SUBJECT: Forwards comments on June 1979 DES. Revised water use diagram
 encl.

SUSQUEHANNA SES
COMMENTS ON DES
ER 100450 FILE 991-2
PLA- 396

DOCKET NOS. 50-387
AND 50-388

Attached are PP&L's comments on the Draft Environmental Statement issued by NRC in June, 1979.

Fig. 2.3. Water Use Diagram for Susquehanna Units 1 and 2. From ER-0L, Fig. 3.3-1.

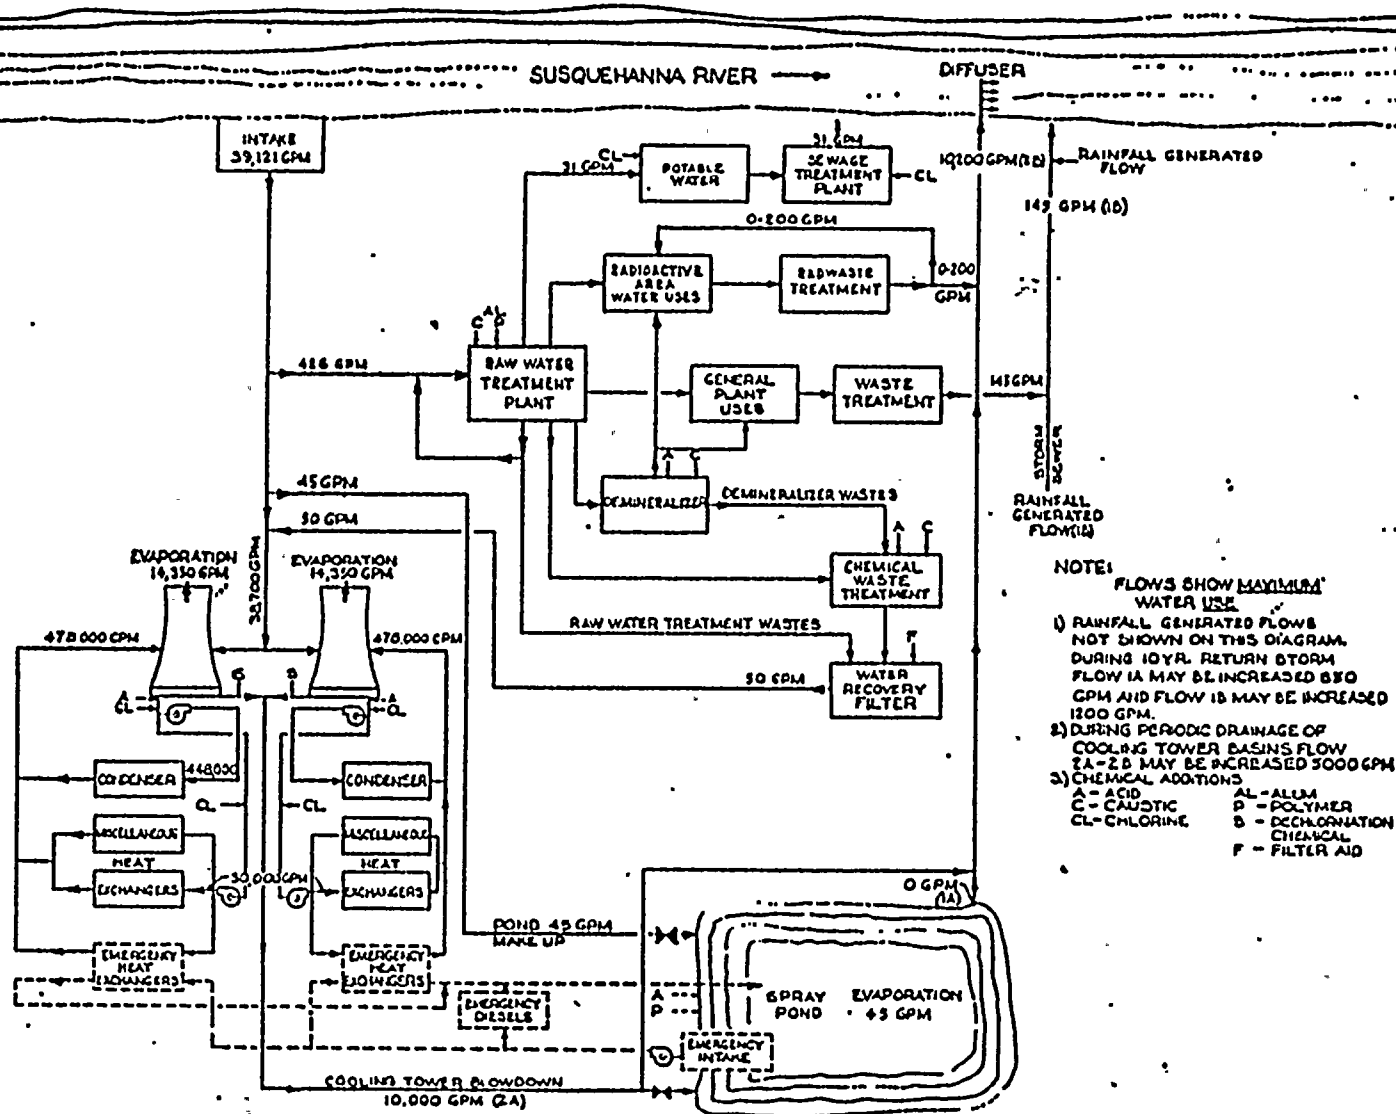
1. Section 2.3.3, pg. 2-11 - Figure 2.3, Water Use Diagram has been revised per the NPDES permit. The parking area hold-up pond has been deleted (see revised Figure 2.3, attached)
2. Section 2.3.4.1, pg. 2-11 - On "line 1" - The monitoring schedule ranged from twice weekly to quarterly. On "line 2" - The monitoring by Ichthyological Associates since 1971 has been weekly instead of daily. Line 8 should read total iron "and fecal coliforms". Figures 2.5 and 2.6 are reversed.
3. Section 2.5.1.3, pg. 2-22 - Add to line 12; "An American peregrine falcon was observed in 1973.:"
4. Section 2.4.2, pg. 2-11 - Local Meteorology

1. Section 3.2.4.1, pg. 3-8 - The parking area hold up pond has been deleted. See revised Figure 2.3 which is attached.
